Queensland Guide to Traffic Management

**Part 6: Intersections, Interchanges and Crossings
Management (2020)**

July 2021

Figure 4.4.4 – Example treatment at roundabout for people walking

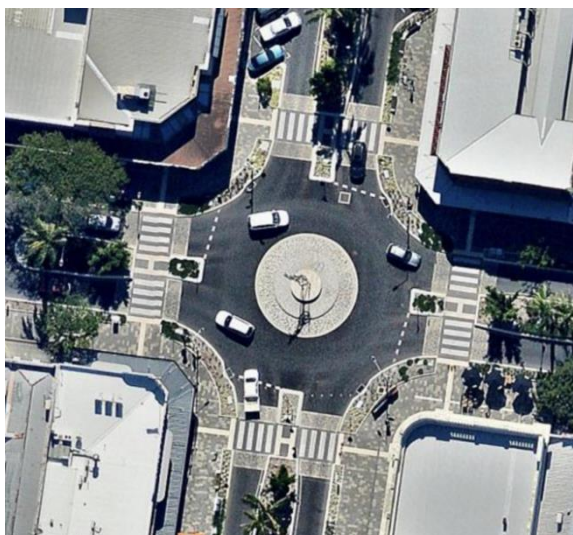
Replace Figure 4.7 in Austroads *Guide to Traffic Management* Part 6 with Figure 4.4.4.
